*City of El Paso – City Plan Commission Staff Report*

**Case No:** PZRZ12-00036
**Application Type:** Rezoning
**CPC Hearing Date:** April 4, 2013
**Staff Planner:** Harrison Plourde, (915) 541-4114, Plourdeht@elpasotexas.gov

## Mission Valley Transfer Station Infill Traditional Neighborhood, Transit Oriented Development Overlay

## Thoroughfare Assemblies

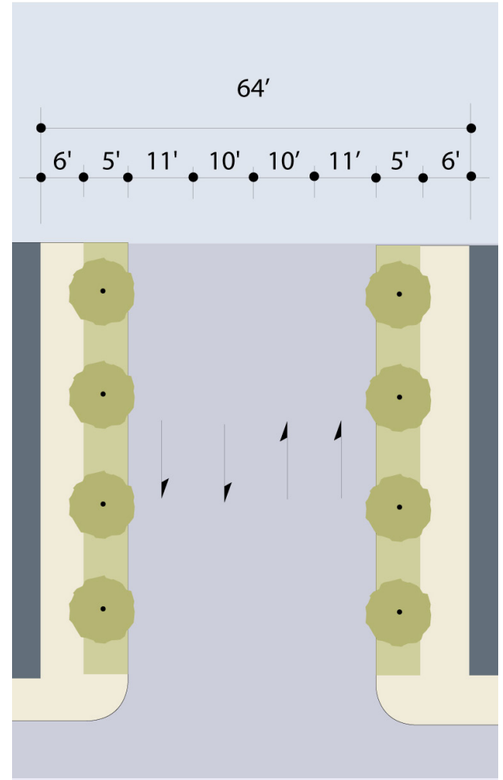
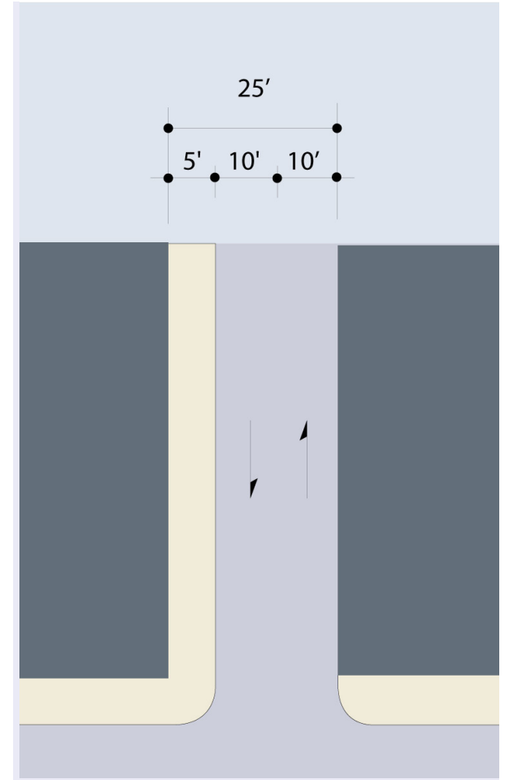
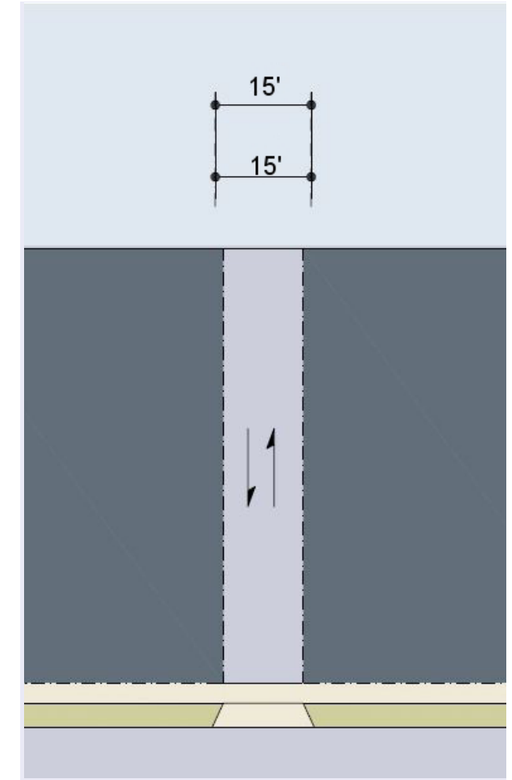
1. Include the following language for the thoroughfare assemblies under all landscape type if none is designated: Trees at 30 feet o.c. average when right-of-way is available.
2. Resolve discrepancy between CS 60-42 on the Thoroughfare Network and CS 64-42 on the Thoroughfare Assemblies.
3. Modify assembly identified as ST 40-30 to include two 10-foot travel lanes, one 8-foot parking lane on one side, and two 6-foot sidewalks.

These comments have been addressed in the final Regulating Plan.
